# Independent Scientific Peer Review

## Of the Steinhatchee River and Priority Springs MFL Technical Report

**Suwannee River Water Management District**

January 2018

Suggested revisions to Figure 6-18 discussed in Comment 12 (colors may vary)

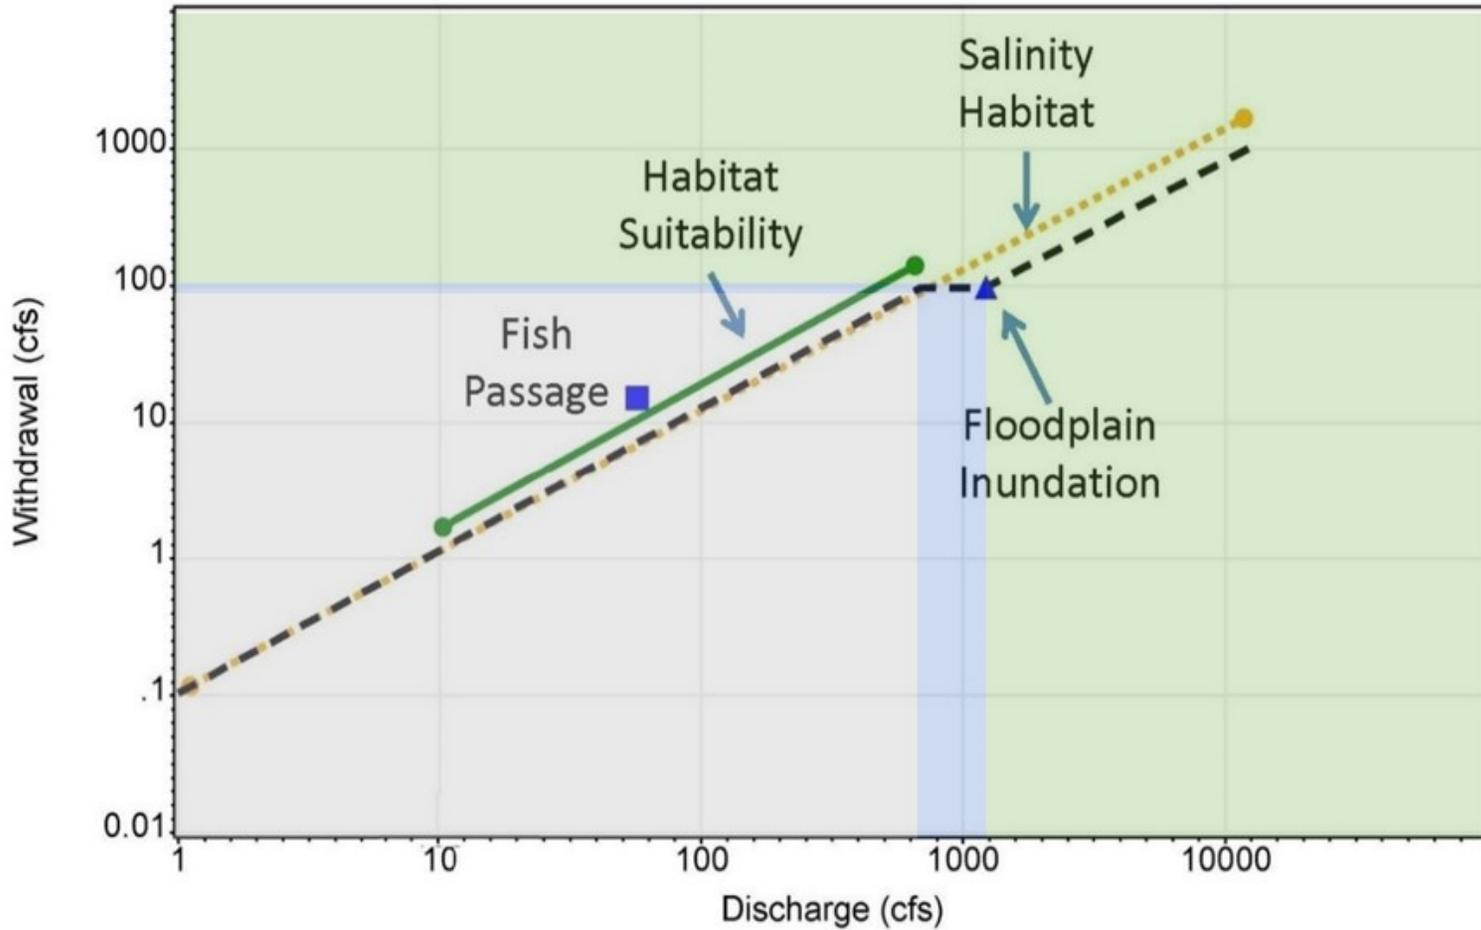
A. Reviewer's Specific Comments	B. Reviewer's Specific Recommended Corrective Action	C. Action to be Taken in Response to Comment
					predominant water use in Steinhatchee is groundwater withdrawals, a low flow cutoff is not needed.
12	Figure 6-18	No	This important figure is hard to interpret. Suggest shading areas of the figure that correspond to each of the 3 flow ranges (see attached example)	Shade areas of the figure that correspond to each of the 3 flow ranges	The figure as presented is felt to be clear for its use. No changes were made.
13	Page 6-28, Section 6.6.2	No	No justification of the springs MFL determination is provided in this discussion. It appears that discharge from these two springs comprises a significant portion of river flow and the springs MFL was chosen to prevent main stem river	Provide justification for the determination of the springs MFLs	The rise, which comprises the bulk of the flow during low flow periods, is integral to the river flow (the MFL applies to the river), therefore, the MFL developed applies to the predominant spring. As in

**Figure 1. Non-tidal water level records from Cedar key and Clearwater, 2002. Water level are in meters NAVD88.**

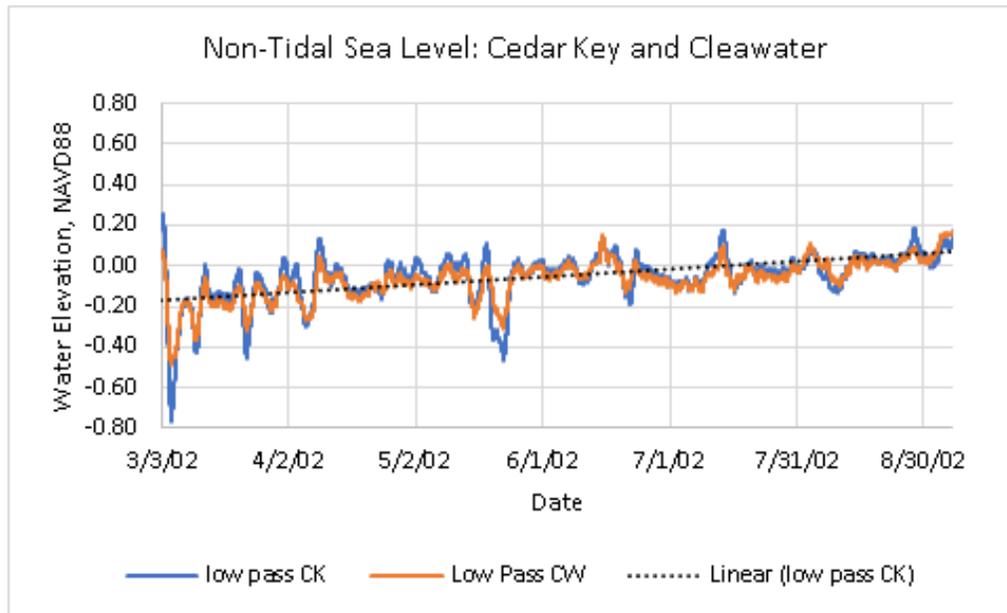
scatter plots of measured and predicted water level data and the time series comparison of model-measured water level data in the GCSM calibration report (2006), it seems likely that the Cedar Key and Clearwater data from the 2002 calibration period were fileted to eliminate the non-tidal part of the records.

Thus, applying the tidally produced GCSM-predicted water level time series from 1995-1999 to the outer boundary of the EFDC Steinhatchee River/estuarine model will produce predicted water levels in the Steinhatchee that are inconsistent with the full spectrum calibration. This inconsistency could produce unknown errors in calculated water volumes and salinity calculations in the Steinhatchee.

**Figure 2. Non-tidal water level records from Cedar key and Clearwater 2015-16. Water levels are in feet, NAVD88.**

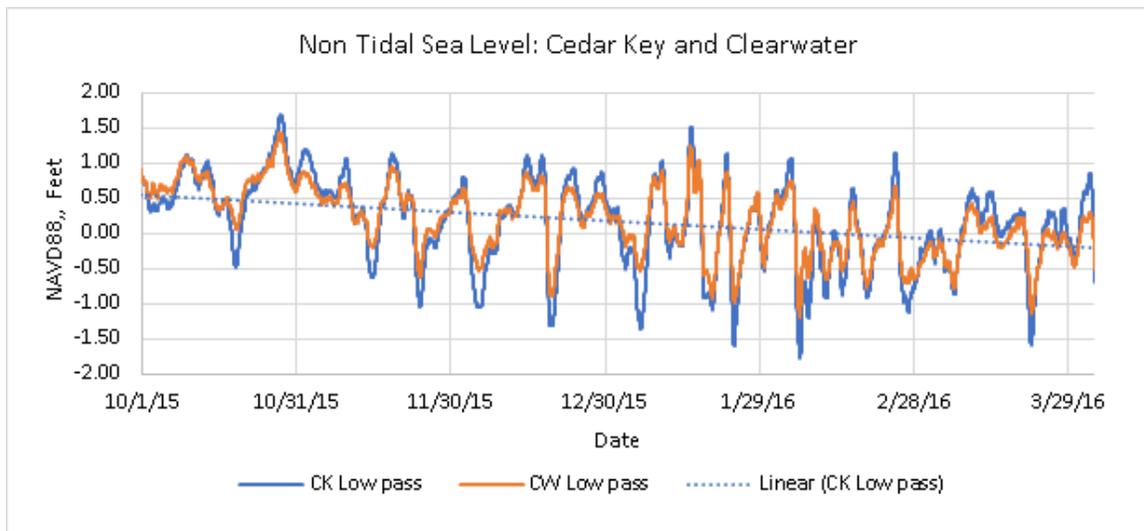
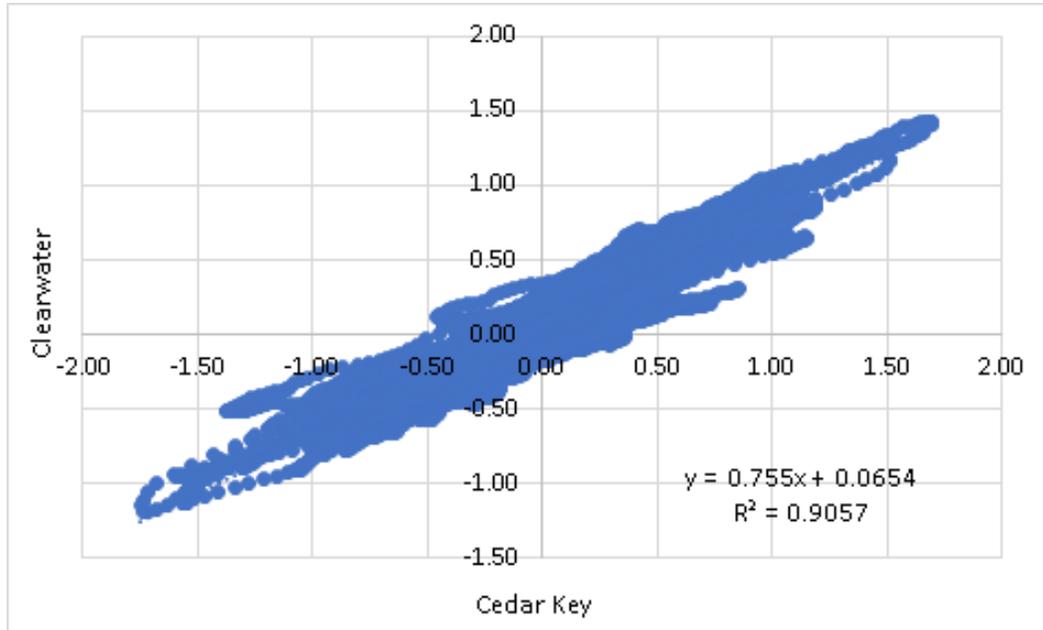
A second approach, more preferable in my opinion, would be to use the 2015-2016 measured water level record at SRWMD 02324190 to calculate a set of tidal constituents for this location, which should be applicable over the outer boundary of the EFDC model. A tide based water level time series could then be produced from for the 1995-99 period and the combined with the low frequency non-tidal water levels from this period derived from the Cedar key NOAA CO-OP station. This would require comparisons between non-tidal water level from SRWMD 02324190 and Cedar Key for the 2015-2016 period. to assure that are similar. Figure 2 shows the Cedar Key an Clearwater records for 2015-16. Note the short-term water levels variations of up to 2 feet and the trend of decreasing sea level of about 0.5 feet during this period. Figure 3 shows the same comparison in the form of a scatter plot shown an  $R^2$  value of about 0.9 between the two non-tidal time series. A non-tidal sea level comparison between the SRWMD 02324190 and Cedar Key water level data should have the same or higher degree of correlation. Once the boundary water levels are constructed from tidal and non-tidal records, the original EFDC runs for the MFL would have to be re-run.
